# Access Compliance Report

## Public Rights-of-Way

### (Curb Ramps)

Intersection ID: 28496	Main Street: AVIARY_HILL_WY	Cross Street: NORTHWOODS_FOREST_DR	Location: W
ADA ID: FFF8EBEA6CD8	Ramp Type: Perp	Initial Pass/Fail: Fail	Overall Compliance: No
Severity Score: 17.5			
Codes/Mitigation Info/Possible Solution		Field Measurements/Component Compliance

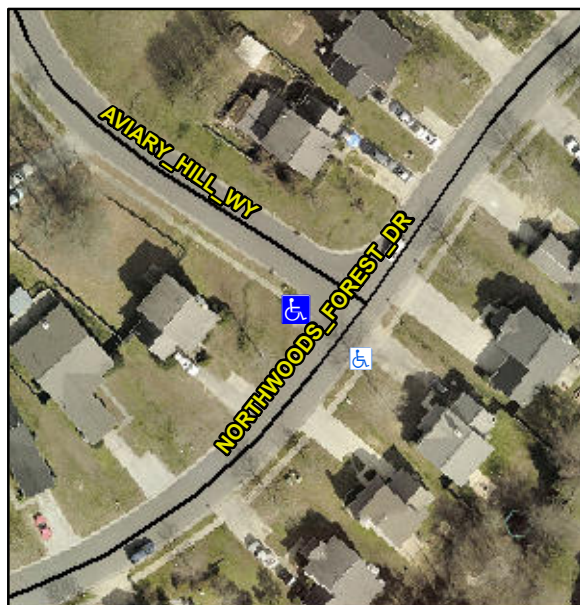
**Not Found, R304.5.1**

Compliance	Description	Data	Compliance	Description	Data
N/A	Ramp Length (in)	94.0	Yes	Ramp Slope (%)	7.2
No	Ramp Width (in)	33.0	Yes	Ramp XSlope (%)	1.5
N/A	Flare Type LT	N/A	N/A	Flare Type RT	N/A
N/A	Flare Slope LT (%)	N/A	N/A	Flare Slope RT (%)	N/A
N/A	Flare Traversable LT?	N/A	N/A	Flare Traversable RT?	N/A
N/A	Landing Length (in)	N/A	N/A	DWS Provided?	N/A
N/A	Landing Width (in)	N/A	N/A	DWS Contrast?	N/A
N/A	Landing Slope (%)	N/A	N/A	DWS Length (in)	N/A
N/A	Landing X Slope (%)	N/A	N/A	DWS Full Width?	N/A
N/A	Landing Curb? (Y/N)	N/A	N/A	DWS Offset (in)	N/A
N/A	Shared Landing?	N/A			
N/A	Gutter Ponding?	N/A	N/A	Gutter Slope (%)	N/A
N/A	Gutter Lip Ht (in)	N/A	N/A	Gutter X Slope (%)	N/A
N/A	Painted X Walk1?	No	N/A	Painted X Walk2?	N/A
	X Walk 1 Direction	To SE		X Walk 2 Direction	N/A
N/A	X Walk 1 Width (in)	N/A	N/A	X Walk 2 Width (in)	N/A
	X Walk 1 Slope (%)	1.8		X Walk 2 Slope (%)	N/A
	X Walk 1 X Slope (%)	1.8		X Walk 2 X Slope (%)	N/A

**Remove & Replace Entire Ramp.**
